Station Road, Great Shelford (21/05276/FUL)

Planning comments re. drainage - response

Project No.	1281
Revision	Rev A
Date	26/01/2022
Client	Churchill Retirement Living
Prepared	L Blackmore
Checked	C Yalden
Authorised	C Yalden
File Ref.	P:\1281 Station Road, Great Shelford\C Documents\Reports\1281 - Station Road, Great Shelford - Drainage comments - response

Appendix A Updated PDL

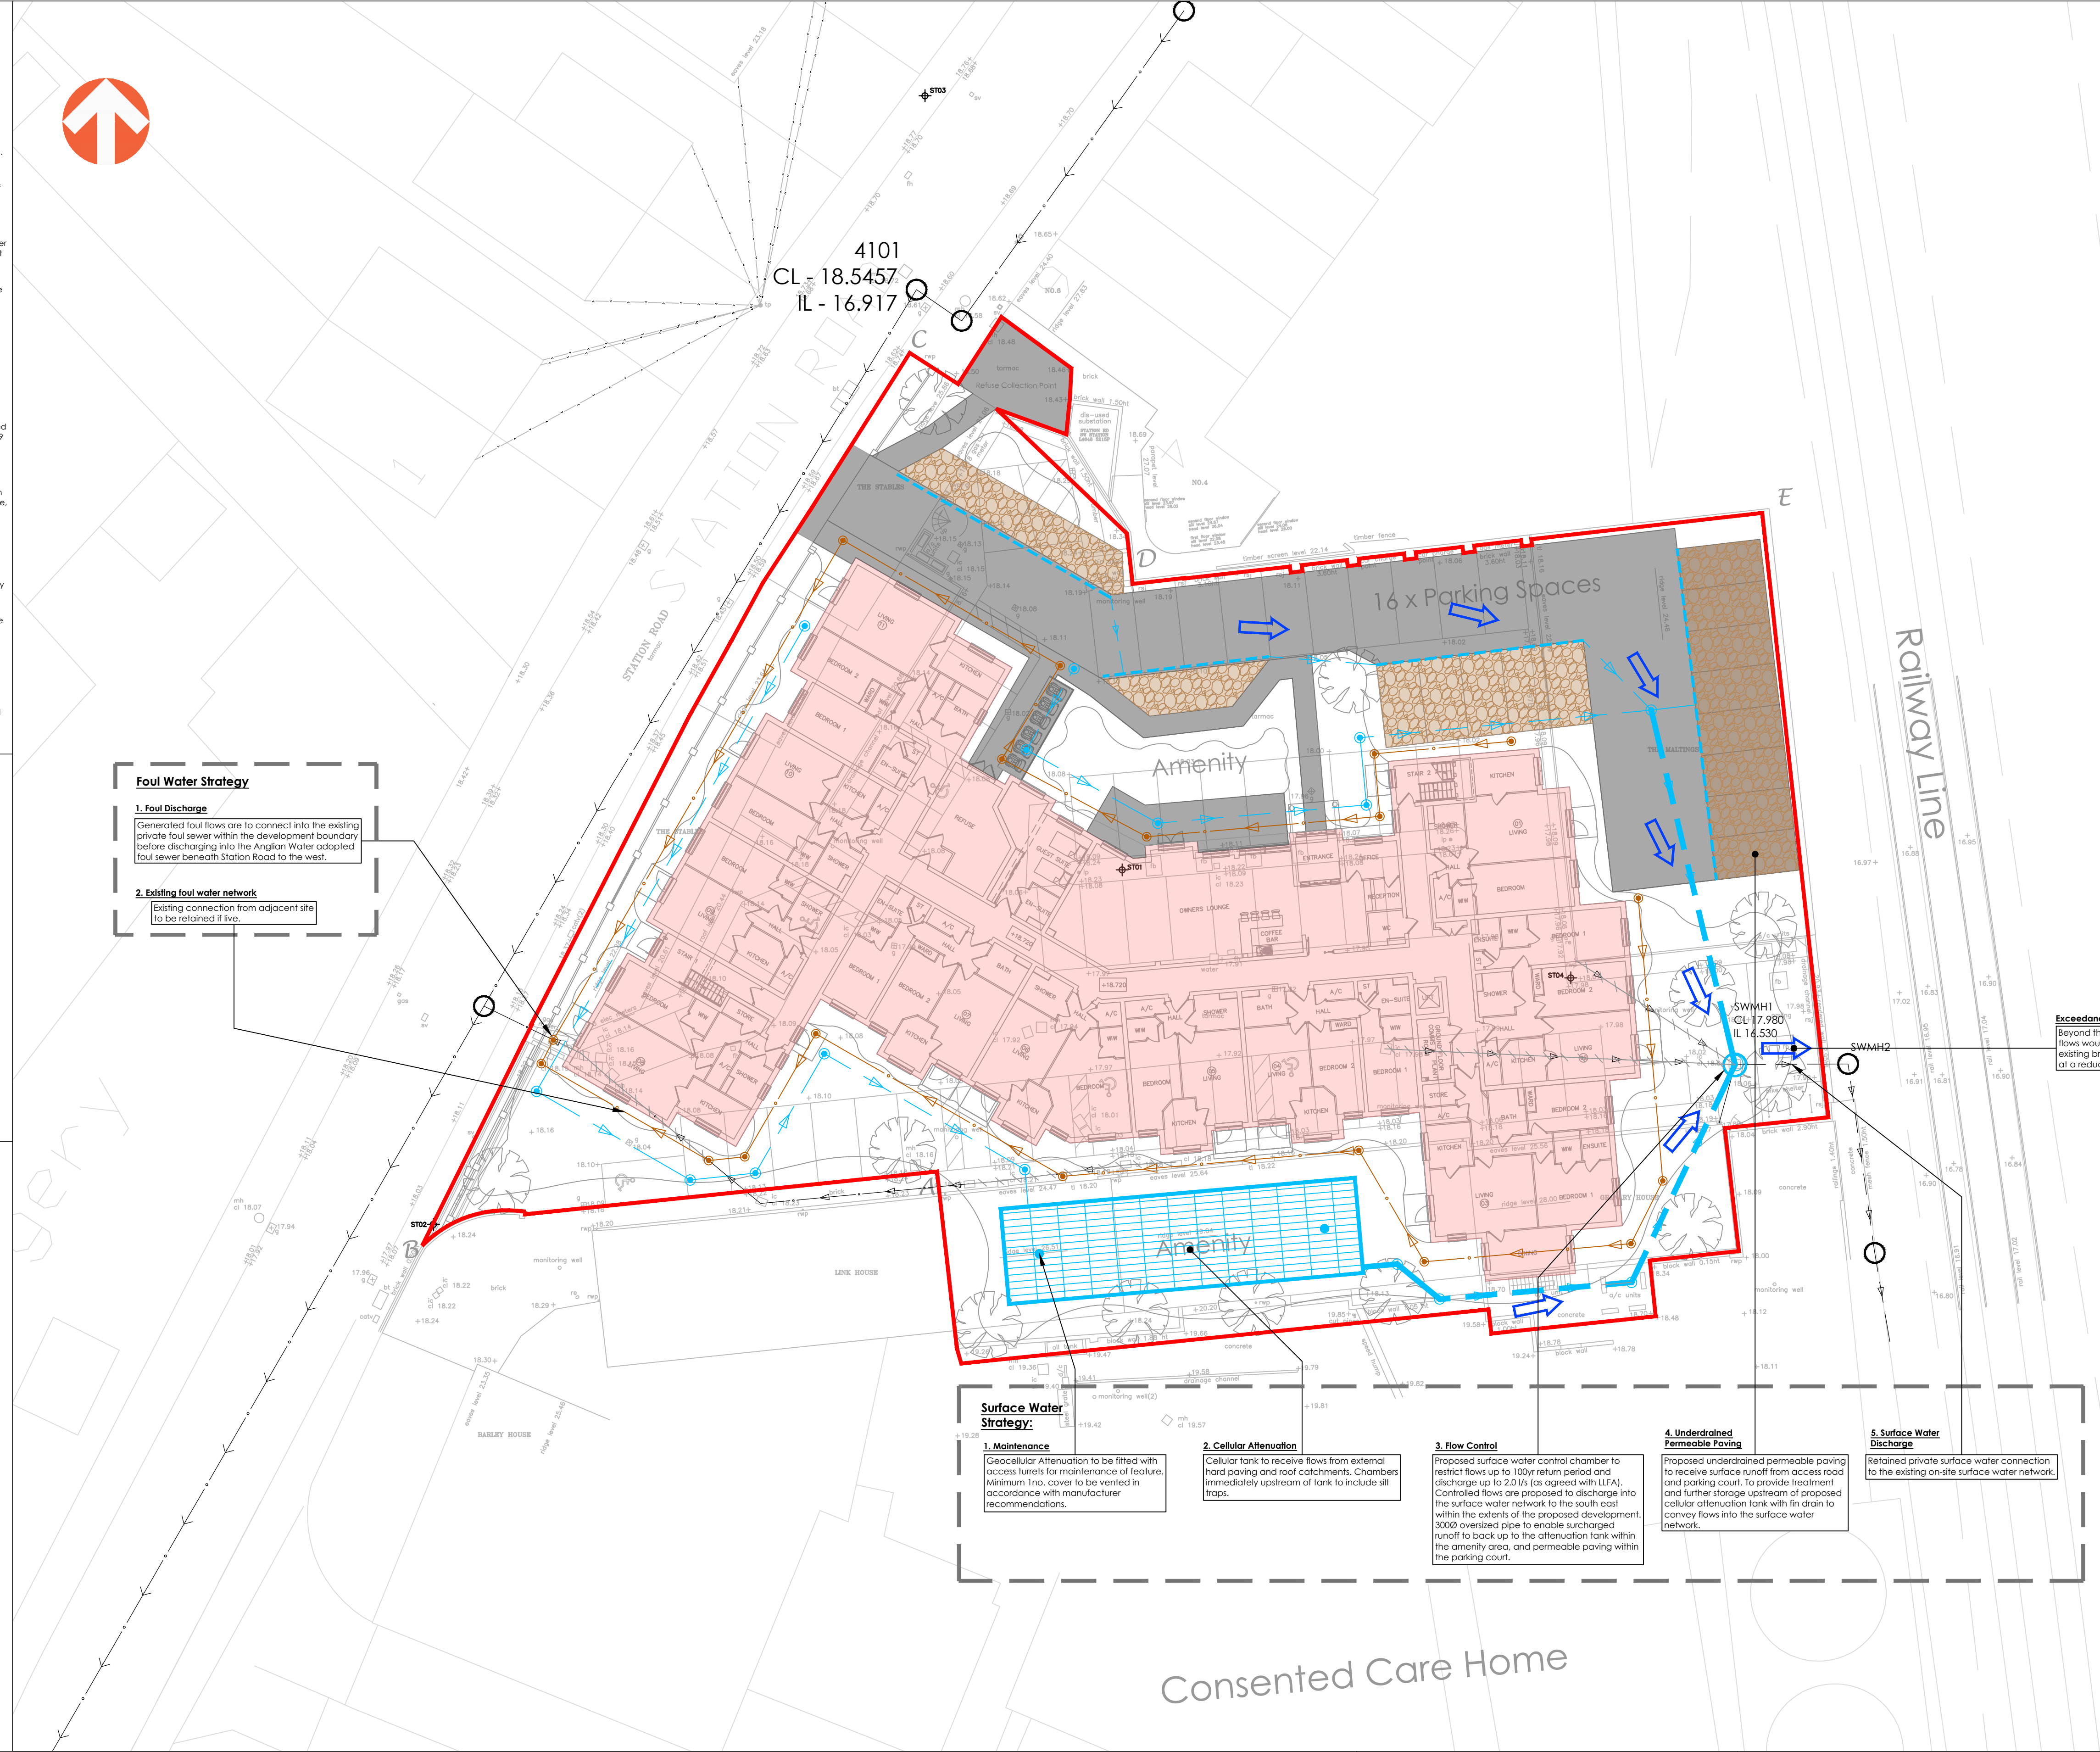
- 2.3 Comment 1: Surface Water Treatment. Appropriate pollution mitigation measures required.
- 2.4 Response LLFA-C1: The water quality from the proposed development is assessed in Section 3 of this note, based on the Simple Index Approach, with required changes applied to the PDL.
- 2.5 Comment 2: Discharge rate. Required discharge rate of 2l/s. Minimum size orifice of 20mm diameter allowed where risk of blockage from debris is minimal.
- 2.6 Response LLFA-C2: The attenuation tank capacity has been increased, and the flow control size reduced to achieve a 2l/s discharge rate. The PDL has been updated accordingly.
- 2.7 Comment 3: Drawings. Inconsistent layouts.
- 2.8 Response LLFA-C3: Apologies for any inconsistencies. The updated PDL (Appendix A) shows the proposed site layout.

- 2.9 Comment 1: Ground investigation of adjacent site.
- 2.10 Response SDW-C1: A geotechnical review is included in Appendix C, and based on the extensive investigations on the adjacent site, with water monitoring included on the proposed development site, infiltration features are not viable. Extracts from the 2018 report by SLR is included in Appendix D, which shows the groundwater table less than 2.5m below ground level.
- 2.11 Comment 2: Discharge rate. Required discharge rate of 2l/s.
- 2.12 Comment SDE-C2: Please see response LLFA-C2 above.
- 2.13 Comment 3: Modelling output for 1:100+CC; recommended to include 1:30; and 1:2 (no surcharge).
- 2.14 Response SDE-C3: The updated Microdrainage modelling output summary is included in Appendix B for 1:100+CC and now include output for the 1:30+CC and 1:2 year storm.

- 2.1 The comments relating to drainage as received from the LLFA (10 January 2022), sustainable drainage engineer (7 January 2022), and Anglian Water (23 December 2021) are addressed and acknowledged in turn. The updated preliminary drainage layout (PDL), in response to the comments, supersedes the PDL submitted with the Flood risk and drainage technical note (AWP, 2021) as part of the planning submission (21/05276/FUL).
- 2.2 The updated preliminary drainage plan (PDL) is included in Appendix A.

3.5 The area ratio of impermeable to permeable paving has been improved, by providing additional areas (49.5m²) of permeable paving in parking bays to the north of the site. This requires a suitable road camber to direct surface water flow to the permeable paved areas, which will be integrated with the detail design.

3.6 The impermeable road area (343.2m²) is now less than twice the total area of permeable pavement (200.5m²) across the site, which is spread along the access road. A ratio of impermeable to permeable of 2:1 is considered adequate for draining impermeable to permeable areas (Interpave, 2018) to prevent excessive silt loads onto the permeable paving and reduce the risk of surface clogging.
